737

Service Bulletin

Number: 737-28-1303
Original Issue: April 26, 2012
Revision 1: January 22, 2015
ATA System: 2800

SUBJECT: FUEL - General - Left Environmental Control Systems Bay Wire Clamp - Inspection and Replacement

FIGURE 1: LEFT SIDE - ENVIRONMENTAL CONTROL SYSTEMS (ECS) BAY - WIRE CLAMP - INSPECTION (SHEET 1 OF 3)

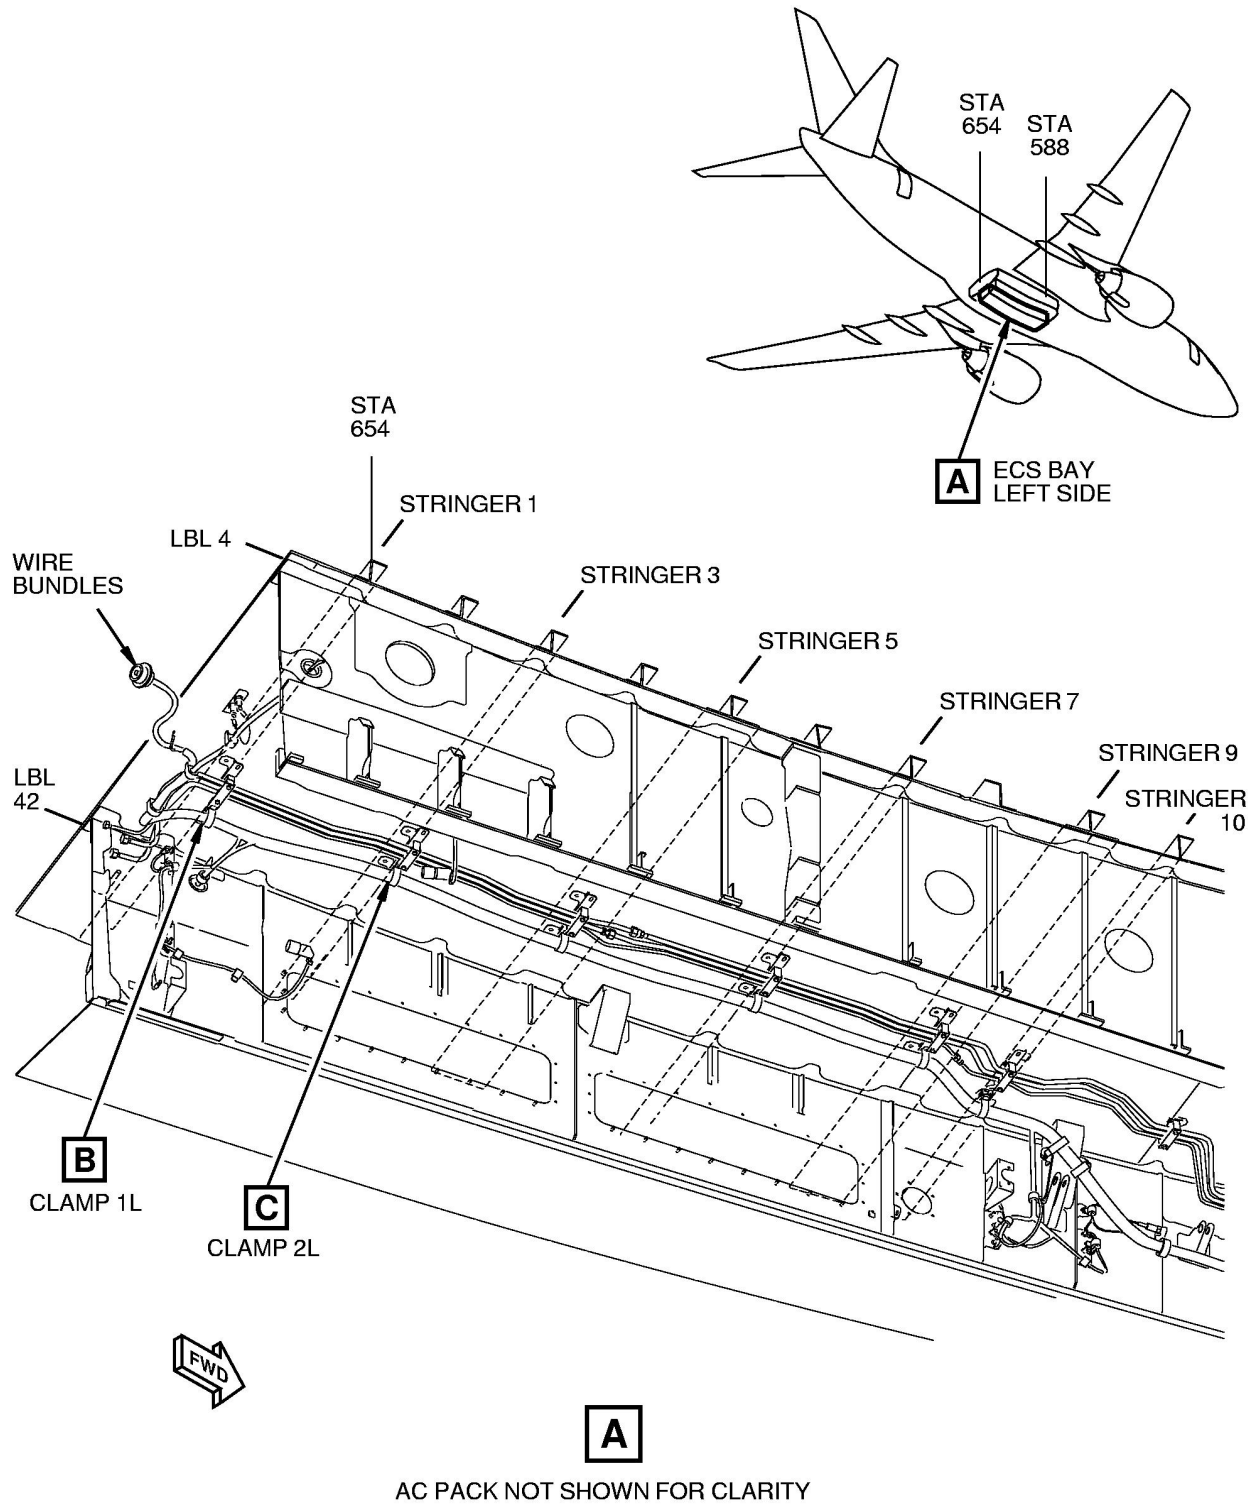
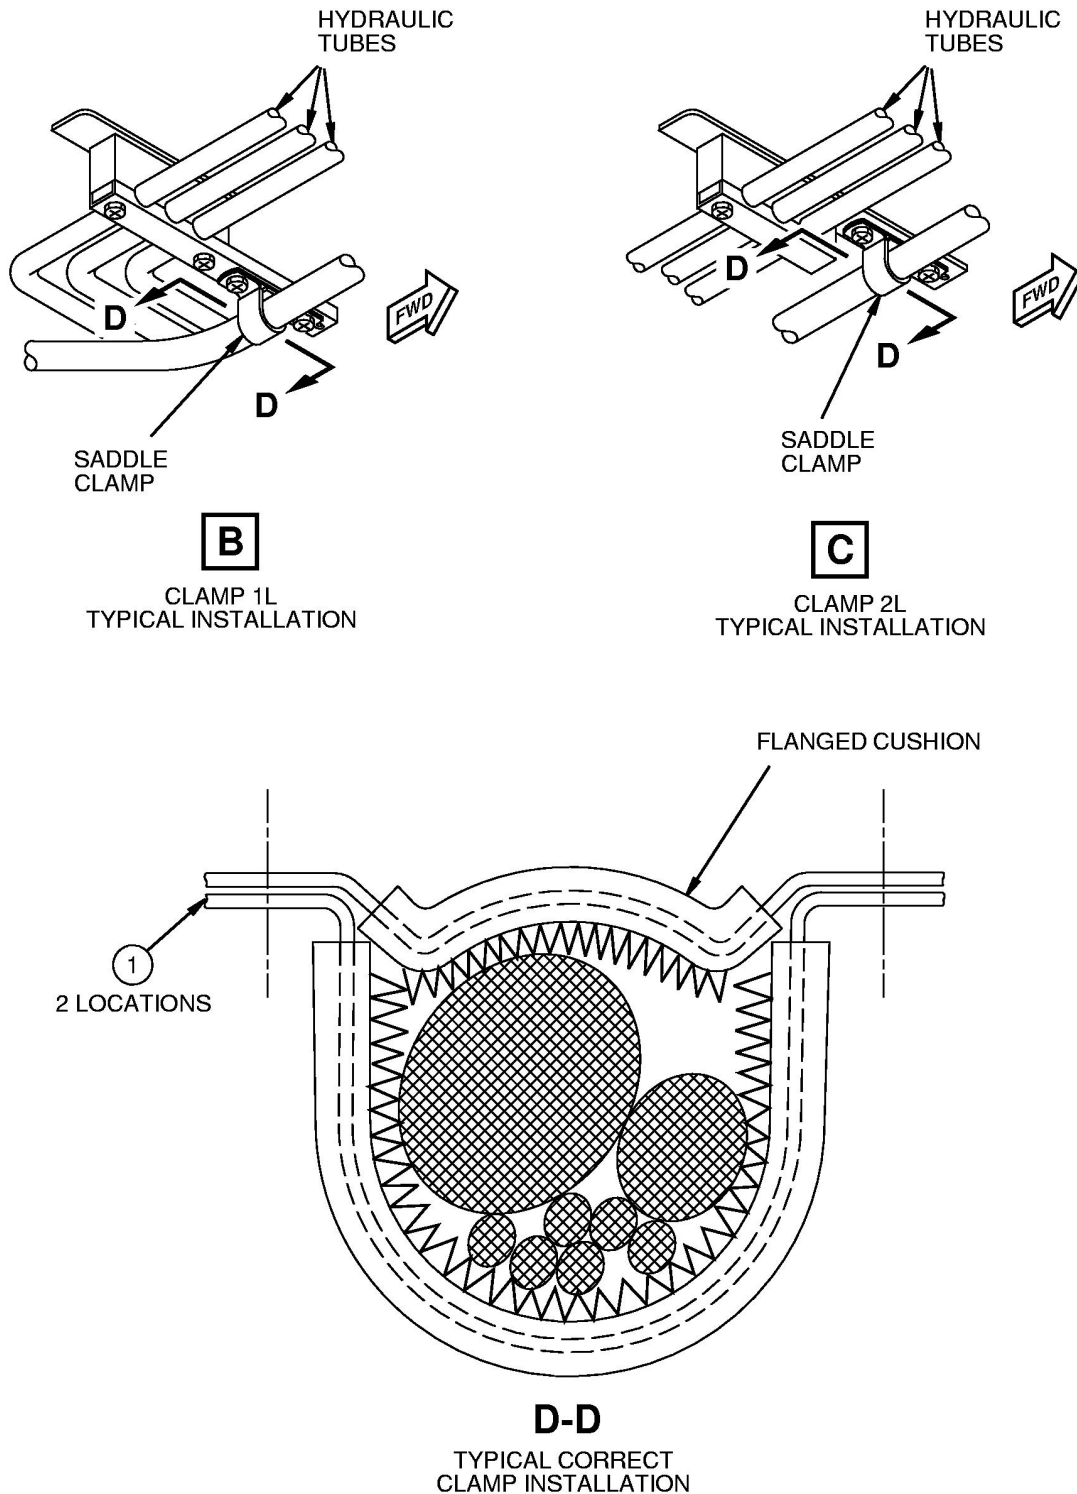
Step	Task	Name	Identification	Qty	More Data
1	Inspect	Clamp	-	2	(a)
(a) Do a Detailed Inspection of the wire bundle to make sure that TA0930034-10, TA0930034-10P, TA0930034-11 or TA0930034-12P wire clamps are installed.

- a. **Group 1:**
In accordance with FIGURE 1.
 - (1) If the installed wire clamps are not TA0930034-10, TA0930034-10P, TA0930034-11 or TA0930034-12P, do a Detailed Inspection for wire damage, repair any damage found, and install new wire clamps in accordance with FIGURE 3.

- (2) If the installed wire clamps are TA0930034-10, TA0930034-10P, TA0930034-11 or TA0930034-12P no more work is necessary.
 - b. **Group 2:**
In accordance with FIGURE 2.

FIGURE 2: LEFT SIDE - ENVIRONMENTAL CONTROL SYSTEMS (ECS) BAY - WIRE CLAMP - INSPECTION (SHEET 1 OF 3)

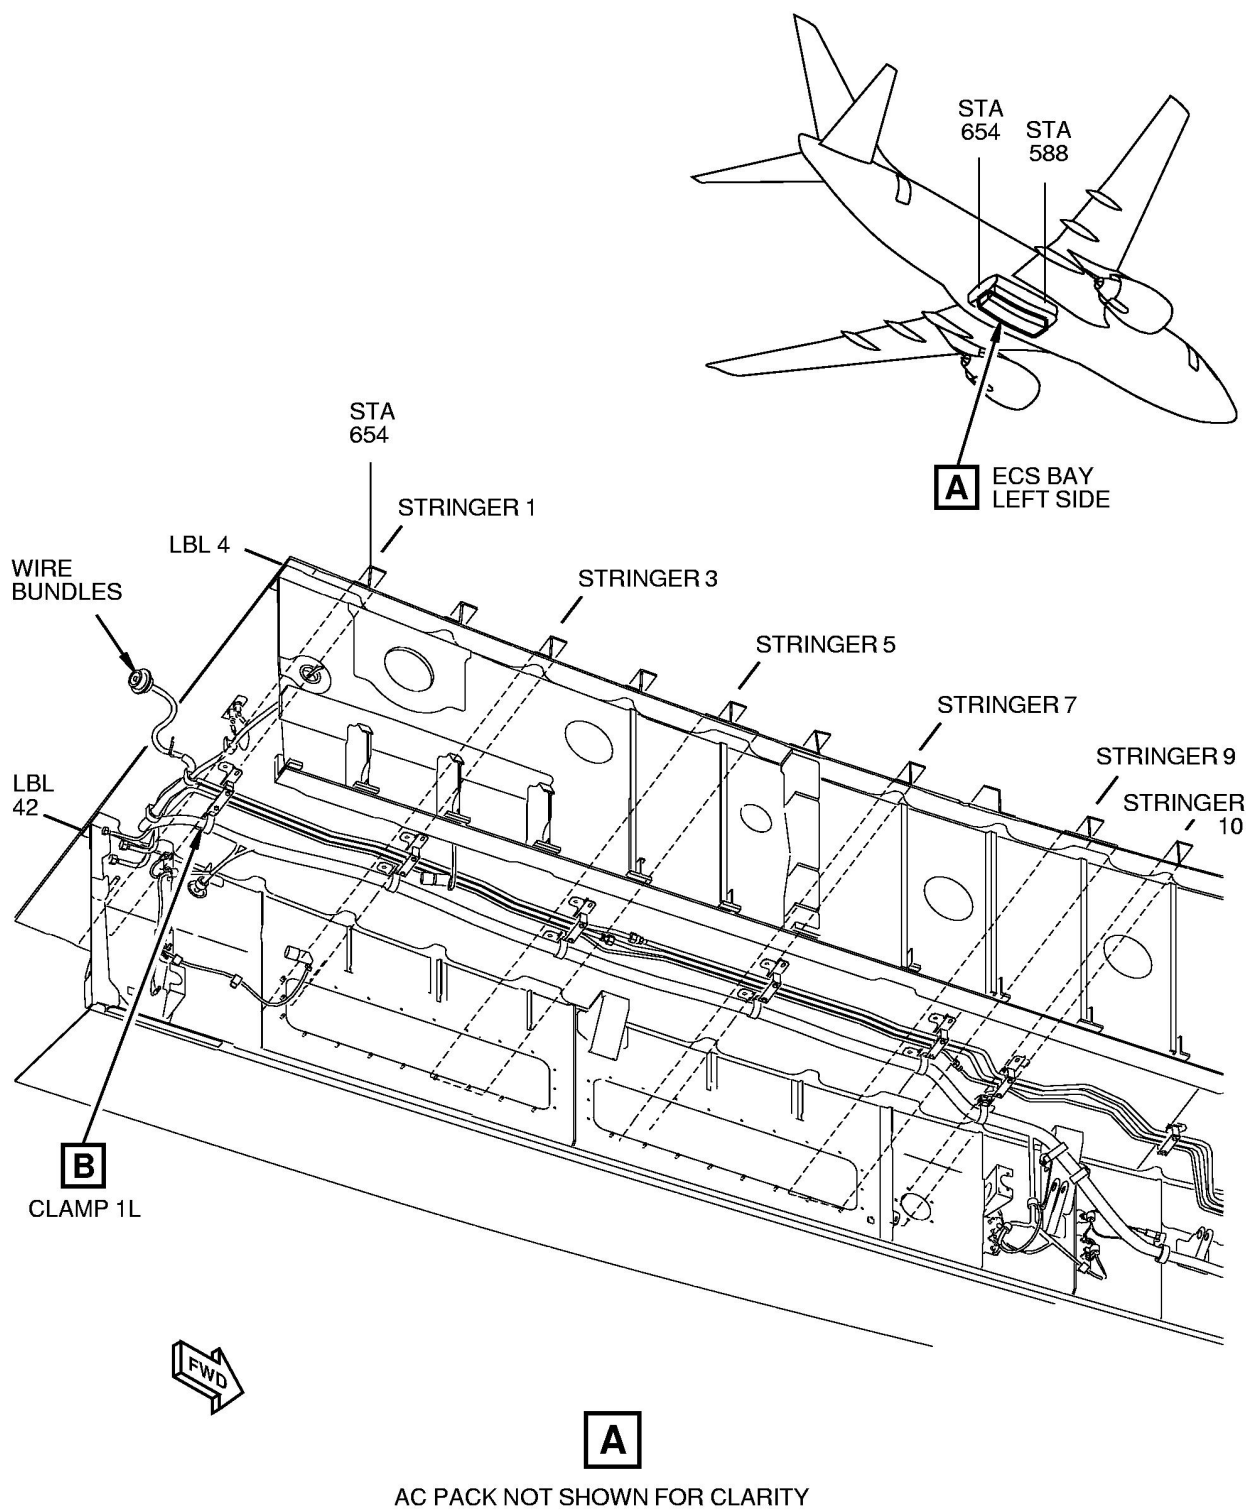
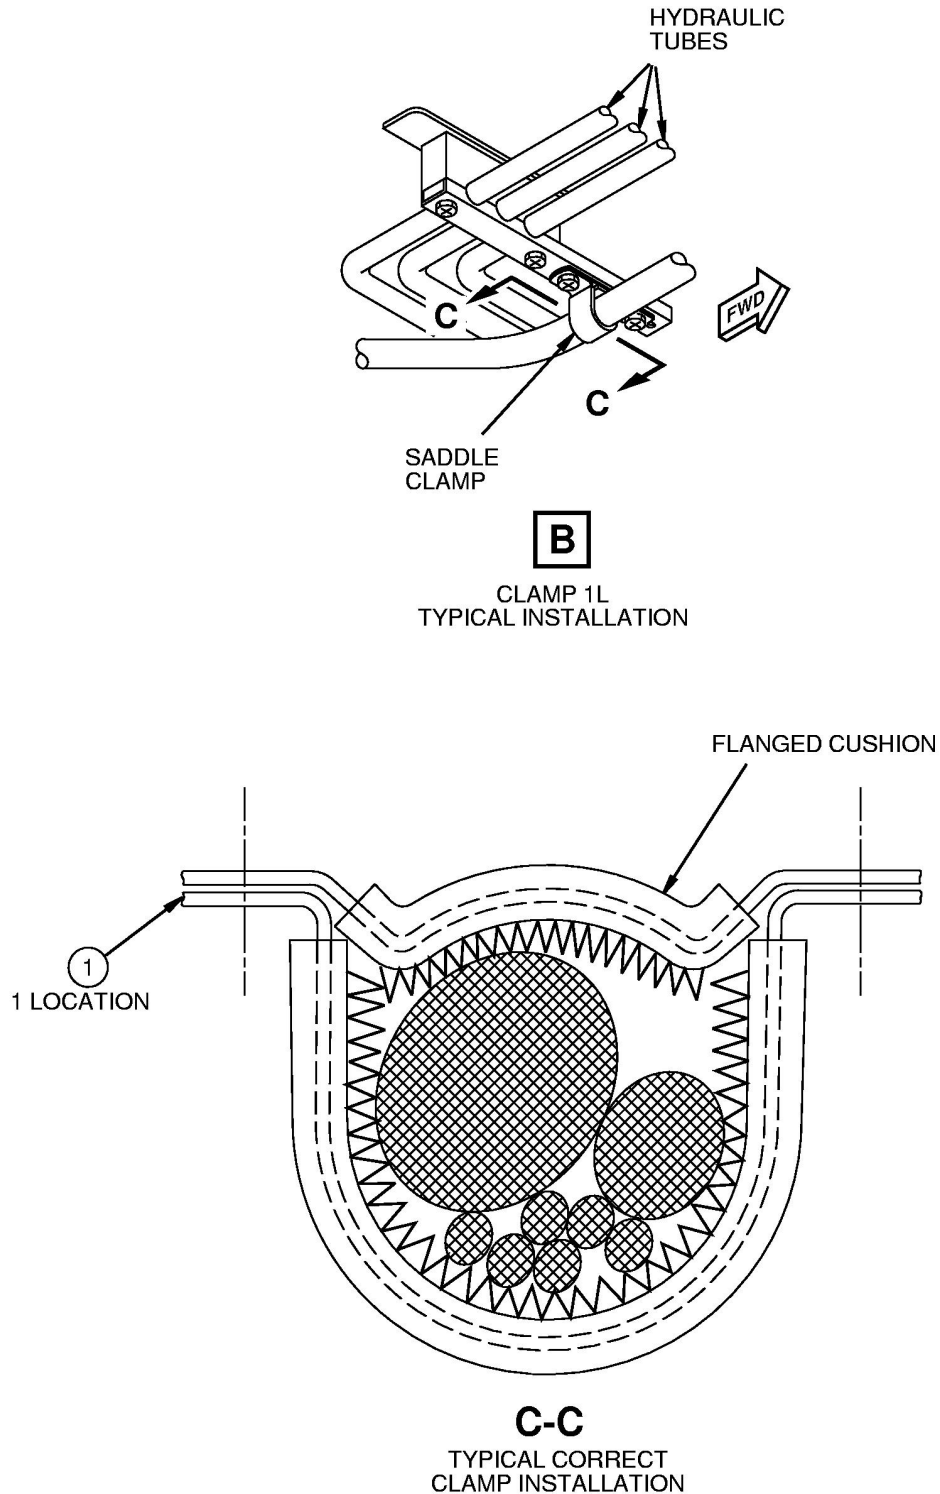
Step	Task	Name	Identification	Qty	More Data
1	Inspect	Clamp	-	1	(a)
(a) Do a Detailed Inspection of the wire bundle to make sure that a TA0930034-10, TA0930034-10P,TA0930034-11 or TA0930034-12P wire clamp is installed.

- (1) If the installed wire clamp is not TA0930034-10, TA0930034-10P, TA0930034-11 or TA0930034-12P, do a Detailed Inspection for wire damage, repair any damage found, and install a new wire clamp in accordance with FIGURE 4.

- (2) If the installed wire clamp is TA0930034-10, TA0930034-10P, TA0930034-11 or TA0930034-12P no more work is necessary.
4. **Group 1:**
Install the primary heat exchanger if removed for access. Refer to 737-600/700/800/900 AMM 21-51-03 as an accepted procedure.

FIGURE 3: LEFT SIDE - ENVIRONMENTAL CONTROL SYSTEMS (ECS) BAY - WIRE CLAMP - REPLACEMENT (SHEET 1 OF 3)

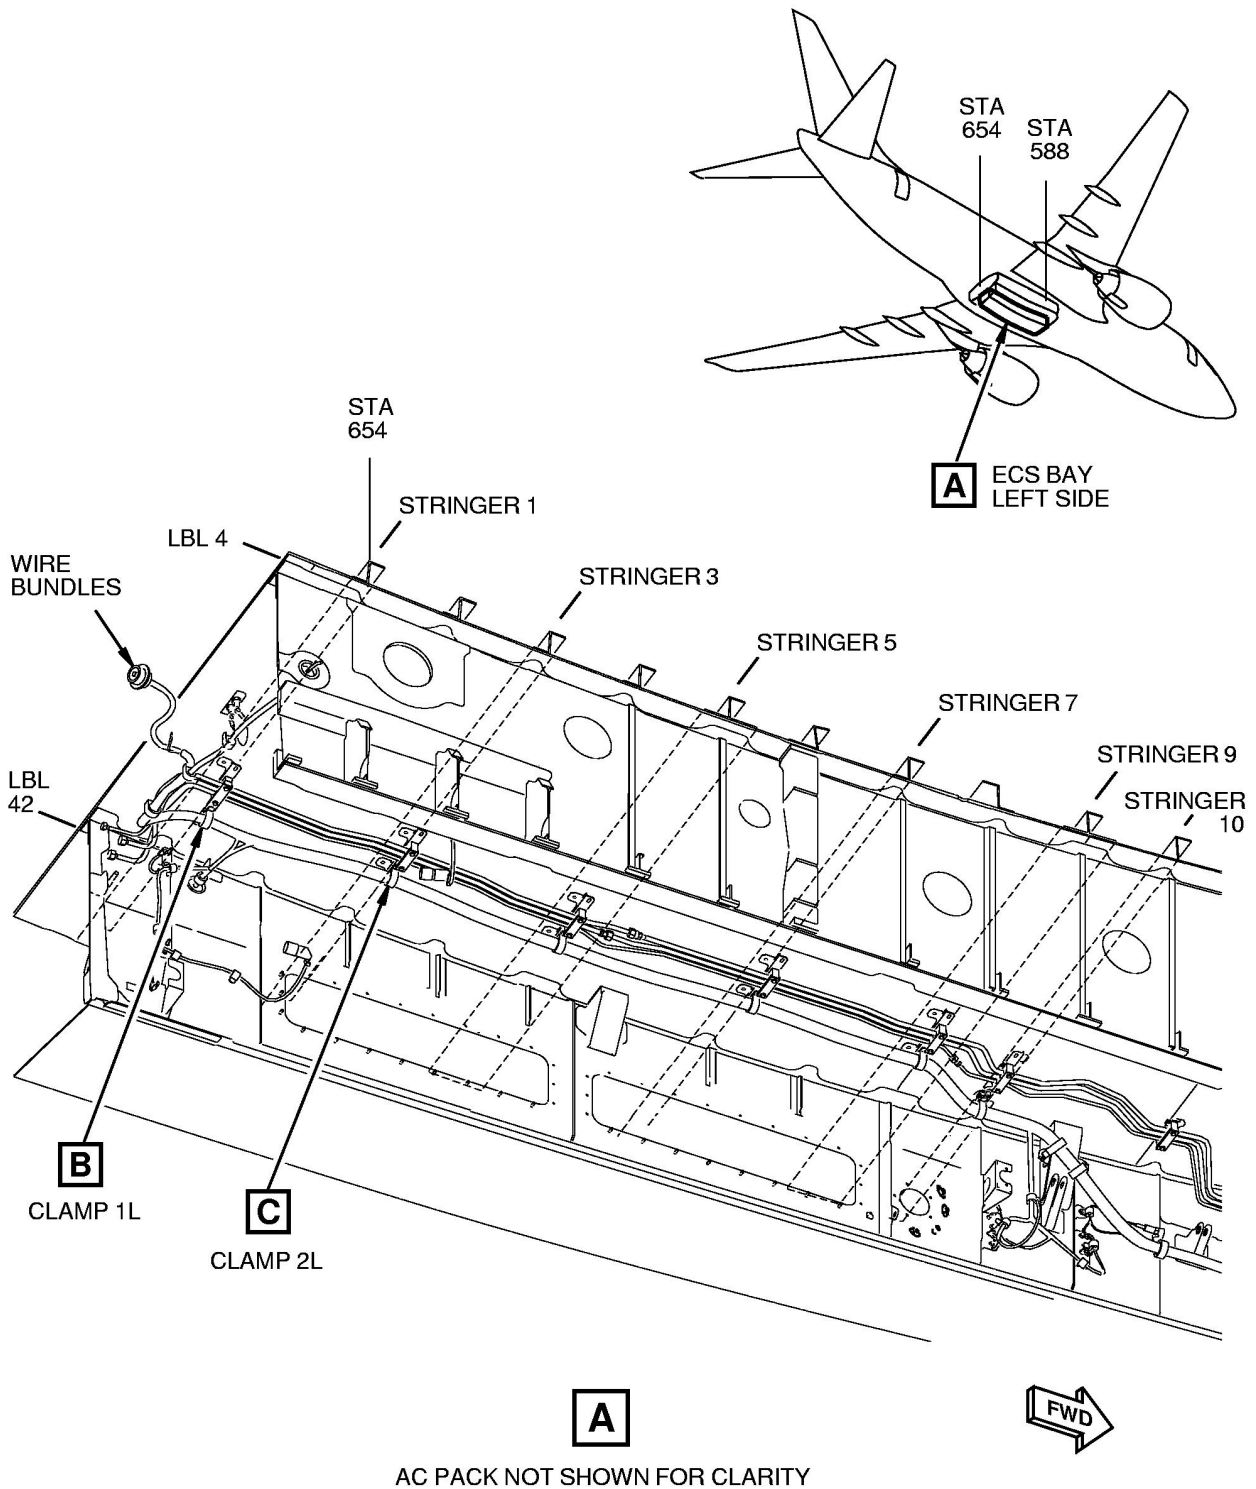
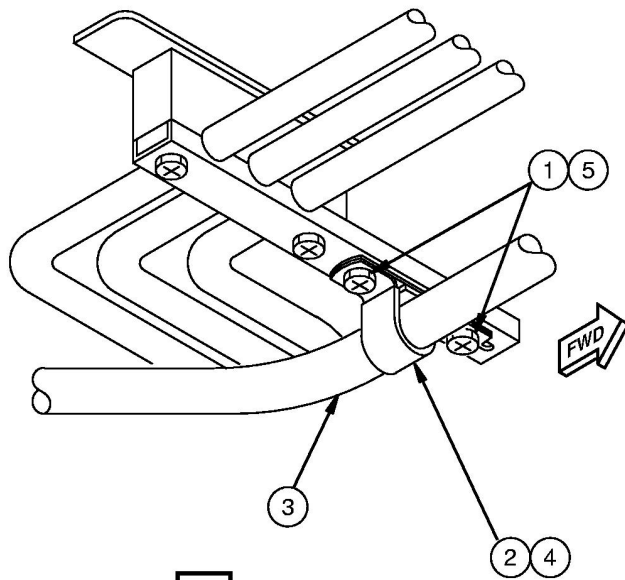
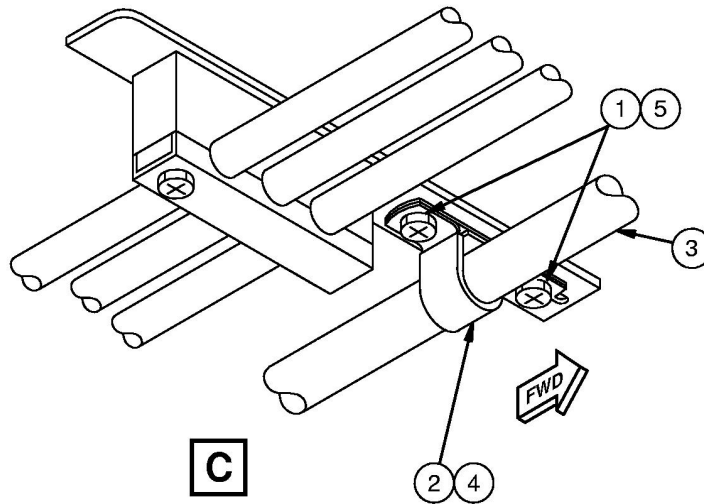
Step	Task	Name	Identification	Qty	More Data
1	Remove / Keep	Fasteners	-	4	(a)
2	Remove	Clamp	-	-	
3	Inspect	Wire Bundle	-	1	(b)
4	Install (New)	Clamp	TA0930034-10 (TA0930034-10P or TA0930034-11 or TA0930034-12P optional)	2	(c) (a)
5	Install (Kept)	Fastener	-	4	(c) (a)
(a) The Quantity shown is the maximum amount that is necessary if both clamps must be replaced.					
(b) Do a Detailed Inspection of the wire bundle for damage (chafing) at the specified clamp locations. If damaged wires are found, repair damaged wires. Refer to SWPM 20-10-13 as an accepted procedure for damage conditions and repair instructions.					
(c) Refer to SWPM 20-10-12 as an accepted procedure.
